UNITED STATES PATENT AND TRADEMARK OFFICE

APPLICATION NO.	FILING DATE	FIRST NAMED INVENTOR	ATTORNEY DOCKET NO.	CONFIRMATION NO.
09/919,304	07/31/2001	Morgan Rey Benson	DP-304879	2487

Office Action Summary

DETAILED ACTION***Election/Restrictions***

Fig. 1A

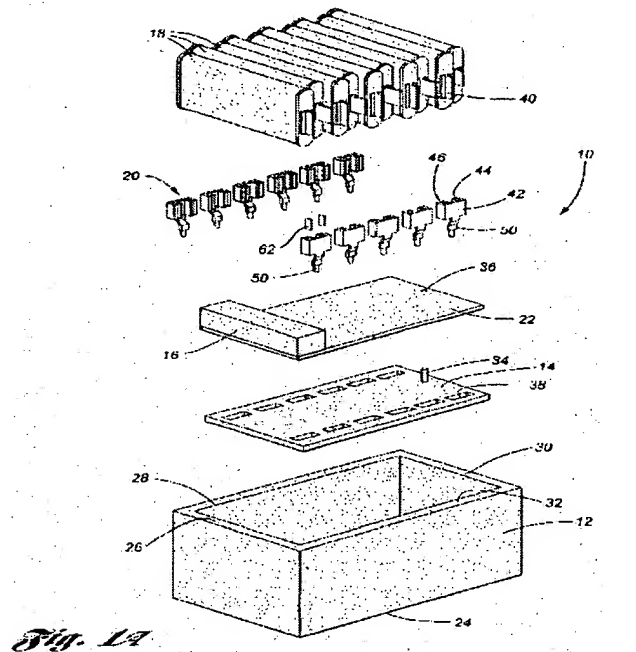
It is also disclosed that the flexible circuit performs current limiting functions (COL 2, lines 5-14. *Thus, it senses current, at least, to some extent.* It is also apparent from Figures 1A and 2 above, that the flexible printed circuit comprises flexible joints which allow the flexible printed circuit to have some move-ability.

Fig. 1C

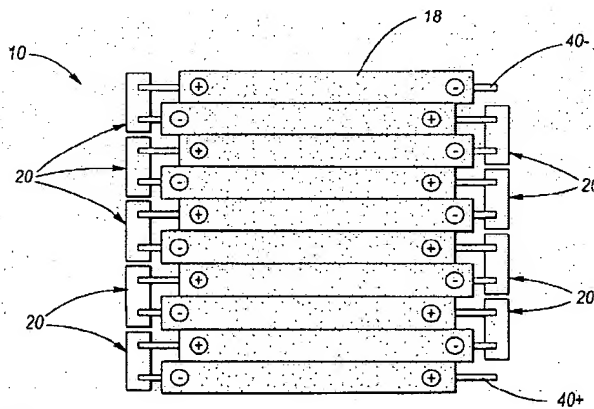
It is disclosed that the battery pack includes a plurality of buss interfaces 20 (COL 3, lines 10-13) having flange portions (col 3, lines 25-30) which connects the modules by edge

connections connecting positive and negative terminals of adjacent cells (COL 3, lines 55-64/
COL 3, line 65 to col 4, line 5/ Figure 1C).

Fig. 1D

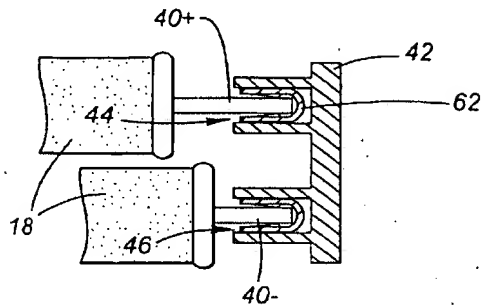
Figures 1D, 4A and 5 illustrate the connecting means including flat features and projecting members which are configured to be connected to the battery terminals and be accommodated through channels.

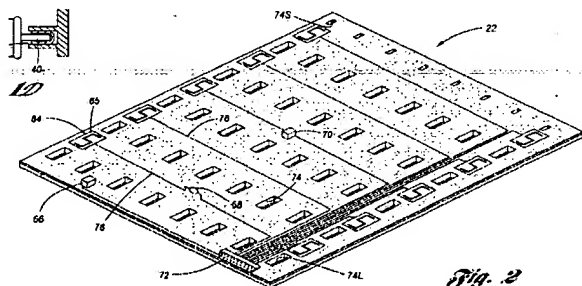
Figure 2 below illustrate a fuse 70 (COL 5, lines 24-30); a connector 72 to transmit electrical signals between circuit 22 and controller 16 (COL 5, lines 33-38); a resistor 68 provided to limit the current transmitted to controller 16 from buss blade 50 (COL 5, lines 15-23) *Thus, the resistor 68 acts as a current sensor.* It is also noted that connector 72 is used for voltage sensing (COL 5, lines 1-5). *Thus, voltage can be correlated to obtain the expected current magnitude.*
